Mechanical Addendum M-001

Date: June 19, 2026
Project: Ontario Aboriginal Housing Services
Location: 321 John Street, Cobourg, Ontario
IVES Project: 22071

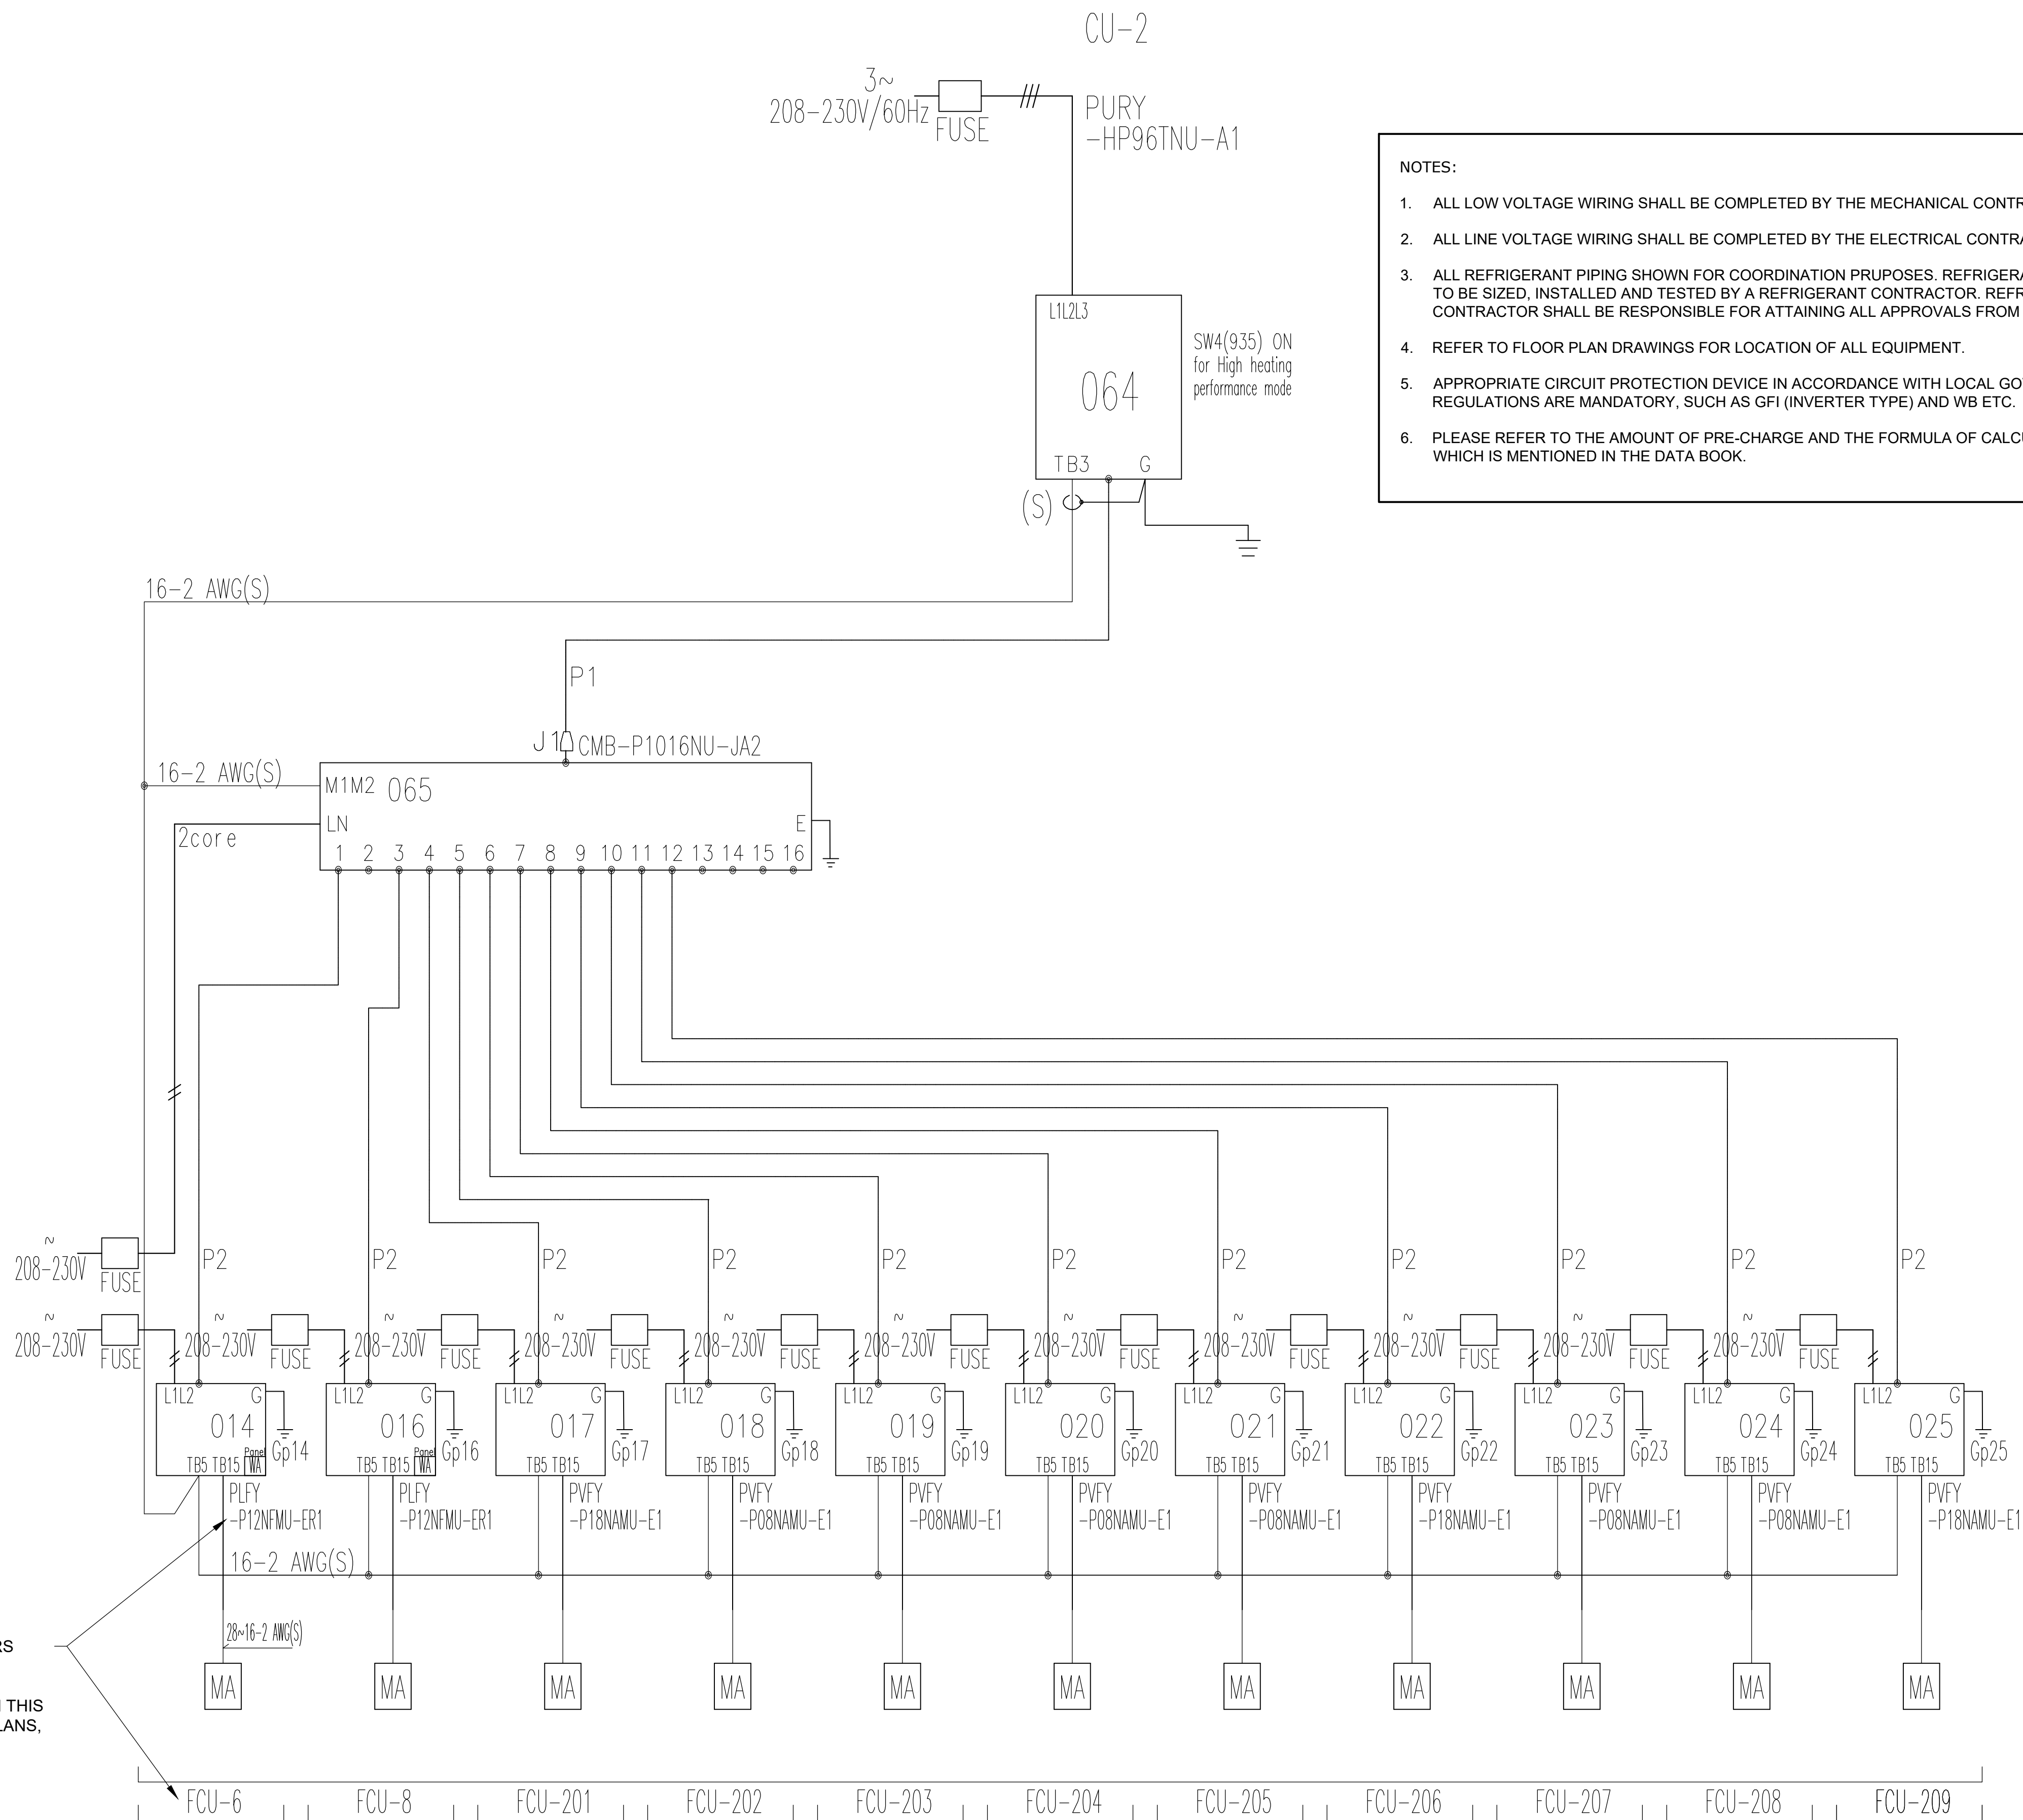
- 1.2.1. Revised refrigerant schematic.
- 1.3. Refer to Mechanical Drawing M-107 – CU-2 Refrigerant Piping Schematic (Re-issued)
 - 1.3.1. Revised refrigerant schematic.

CU-3 REFRIGERANT PIPING SCHEMATICS

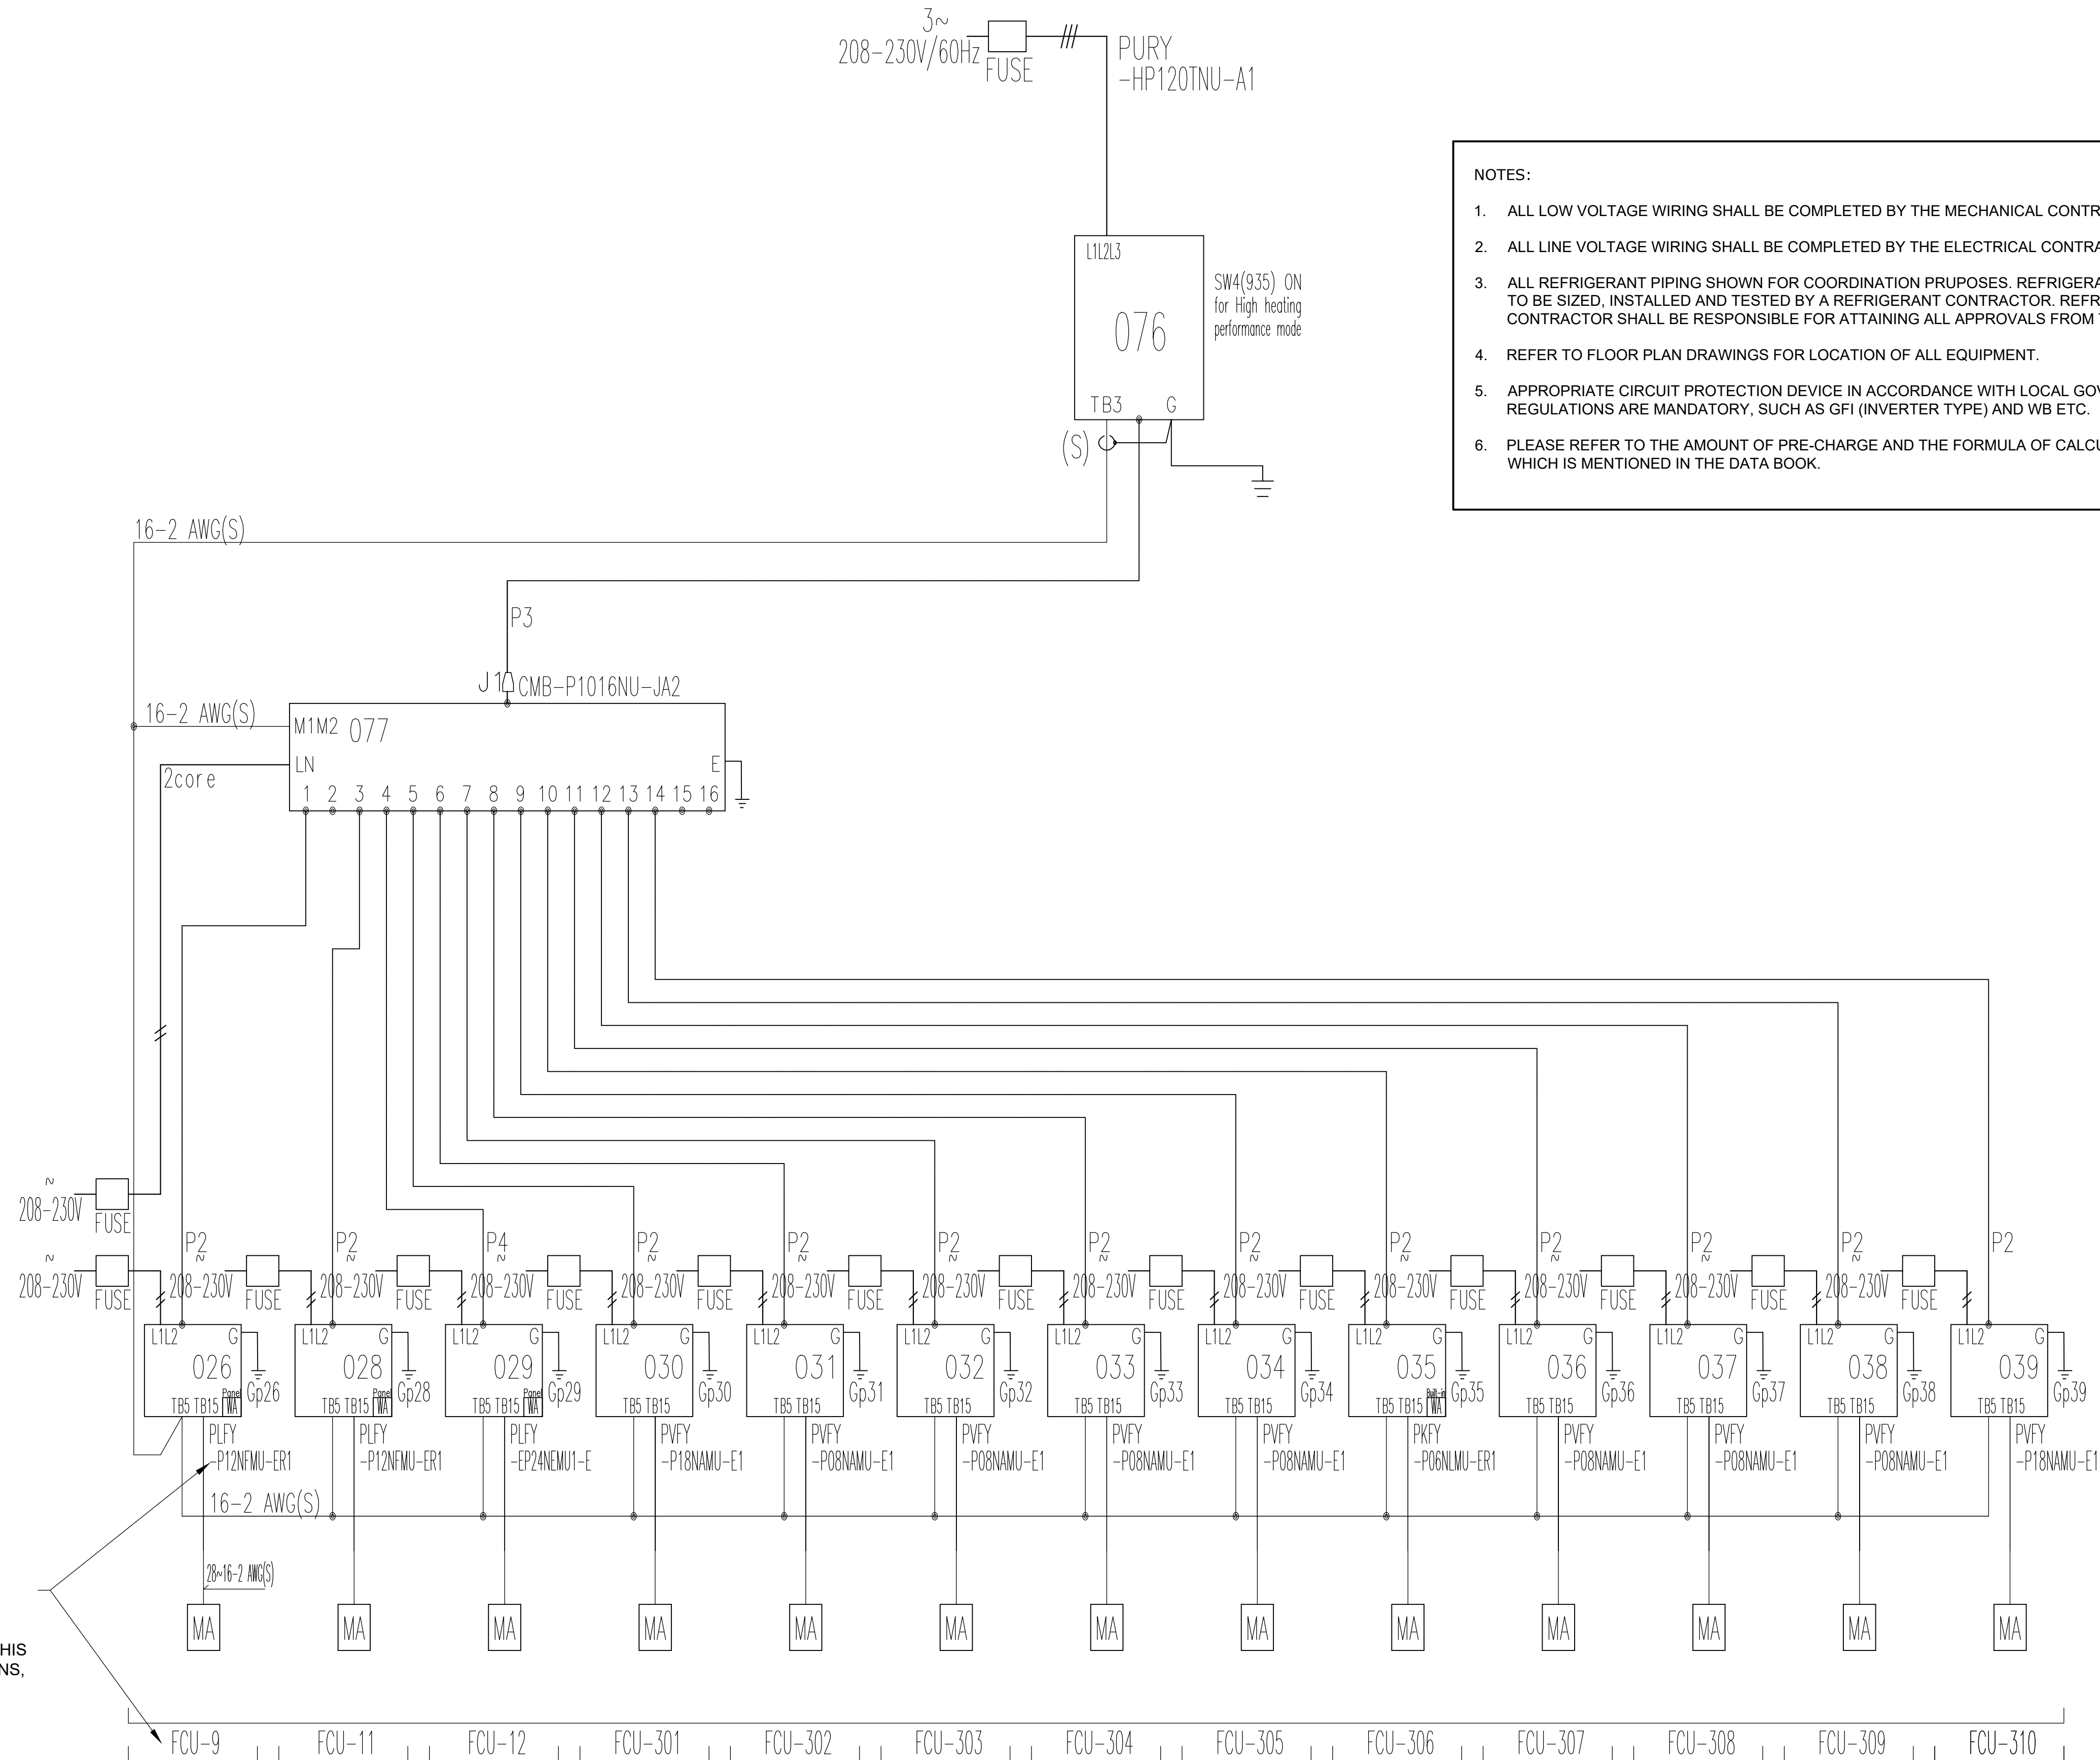
- 1.4. Refer to Mechanical Drawing M-108 – CU-3 Refrigerant Piping Schematic (Re-issued)
 - 1.4.1. Revised refrigerant schematic.
- 1.5. Refer to Mechanical Drawing M-109 – Sanitary Piping Schematic - West (Re-issued)

M-109

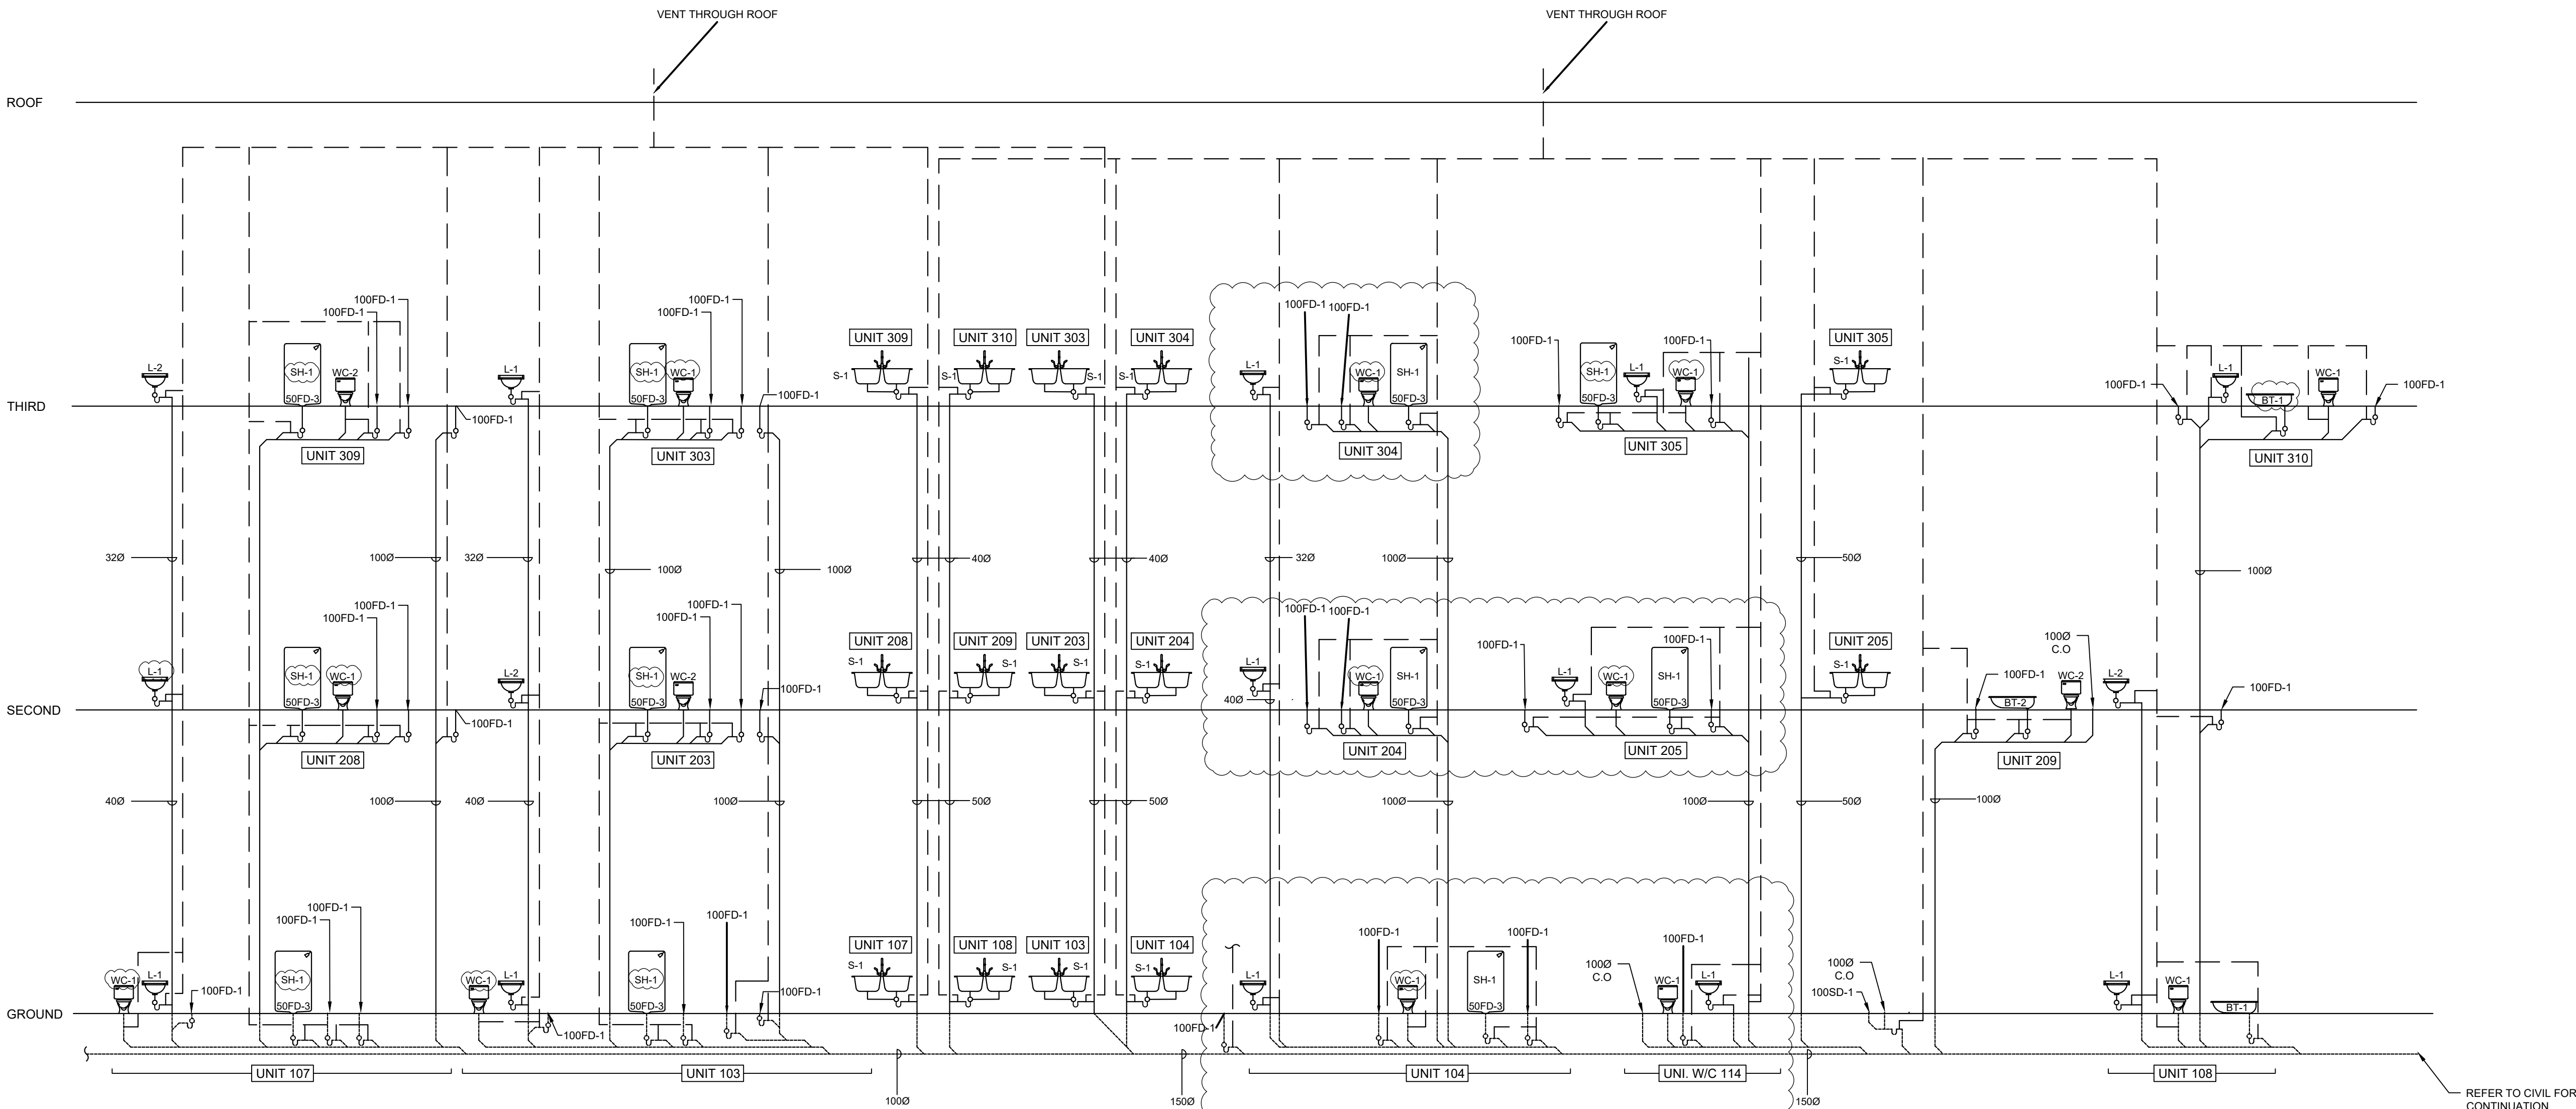
- 1.5.1. Revised as indicated.
- 1.6. Refer to Mechanical Drawing M-110 – Sanitary Piping Schematic - East (Re-issued)
 - 1.6.1. Revised as indicated.
- 1.7. Refer to Mechanical Drawing M-113 – CU-4 & CU-5 Refrigerant Piping Schematics (Issued)
